C. K. Millen, being first duly sworn, deposes and says;
That he is Senior Vice President of Operations of Public Service
Company of Colorado, the Licensee herein; that he has read the
foregoing Application for Amendment to Appendix A of Facility
Operating License and knows the contents thereof, and that the
statements and matters set forth therein are true and correct
to the best of his knowledge, information and belief.

ATTACHMENT 1

7.1 ORGANIZATION, REVIEW AND AUDIT-ADMINISTRATIVE CONTROLS

Fig. 7.1-1

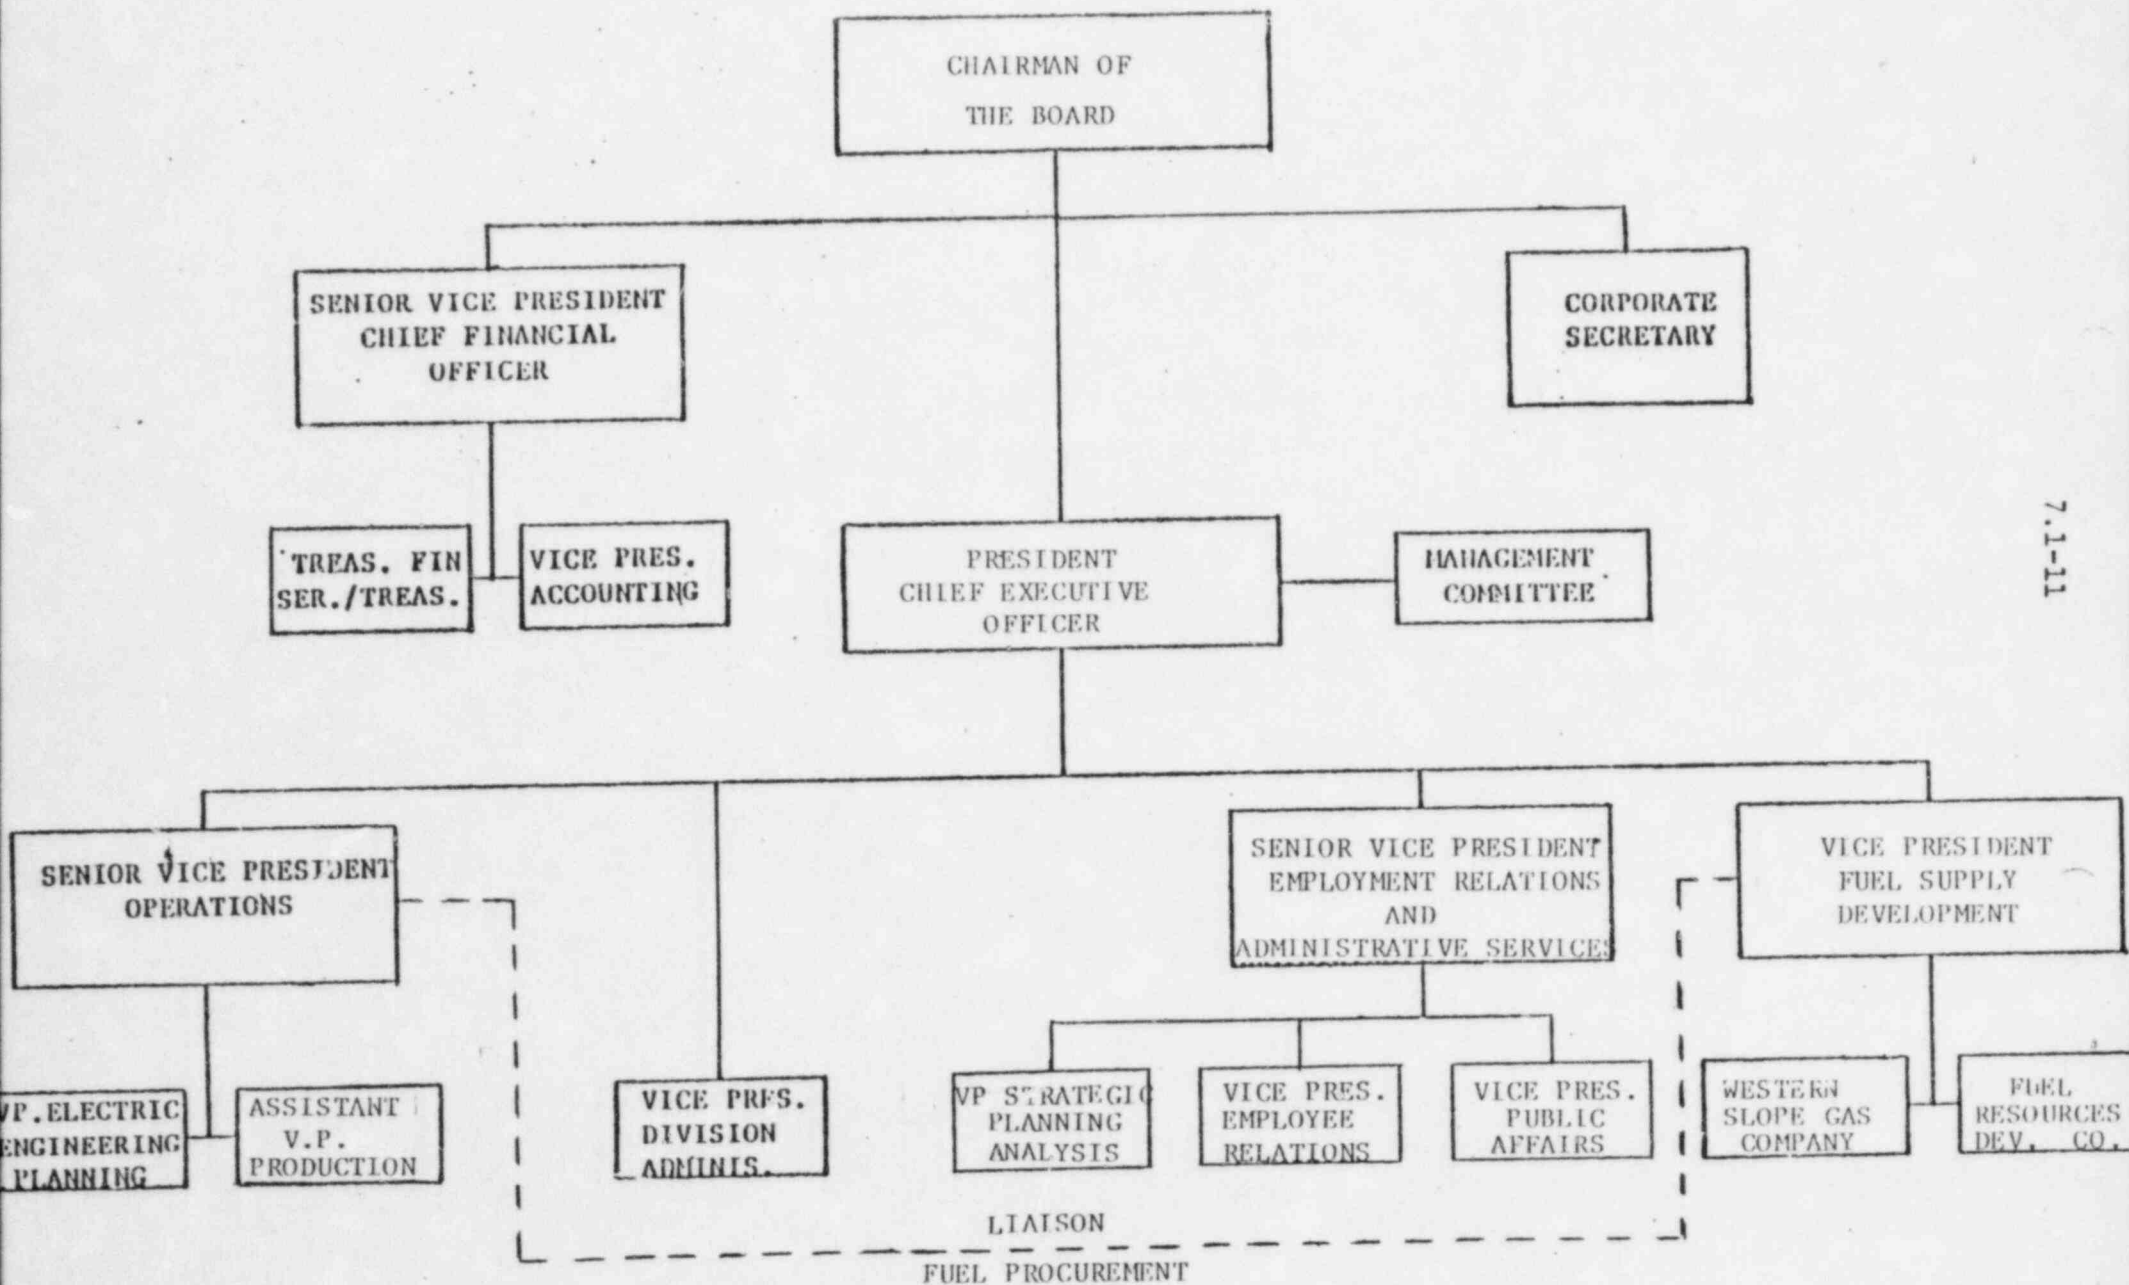
- a. The Operations Manager is directly responsible for overall facility operation and shall delegate in writing this responsibility during his absence.
- b. In all matters concerning the Plant Operations Review Committee (PORC), the Administrative Services Manager will report to the Operations Manager.
- c. In all matters pertaining to operation and maintenance of the plant and to these Technical Specifications, the Operations Manager shall report to, and be directly responsible to, the Manager, Nuclear Production. The administrative and departmental management organizations are shown in Figures 7.1-1 and 7.1-2.
- d. Organization for conduct of operations of the plant is shown in Figure 7.1-3.

Fig. 7.1-2

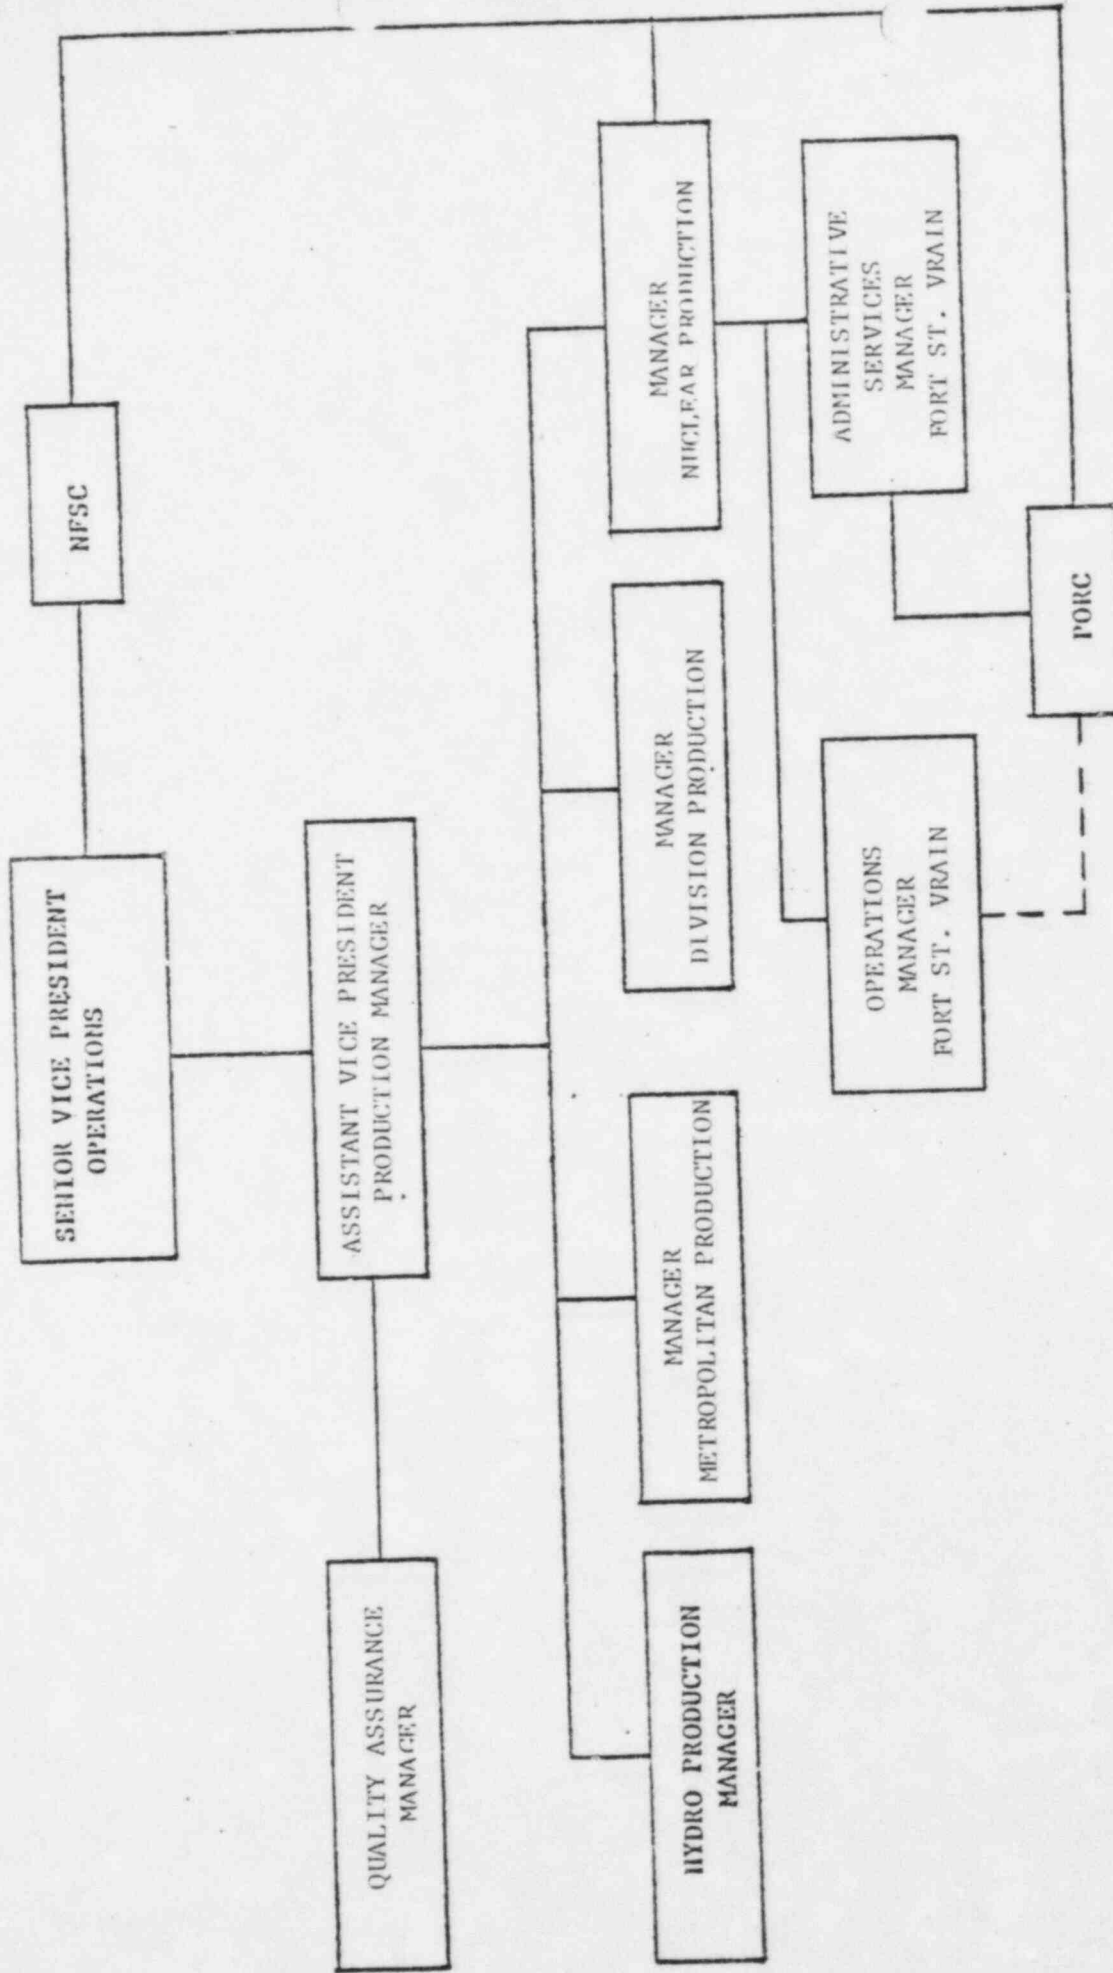
NFSC - Nuclear Facility Safety Committee
 PORC - Plant Operations Review Committee
 Chaired by
 Administrative Services Manager;
 PORC reports administratively
 to Operations Manager
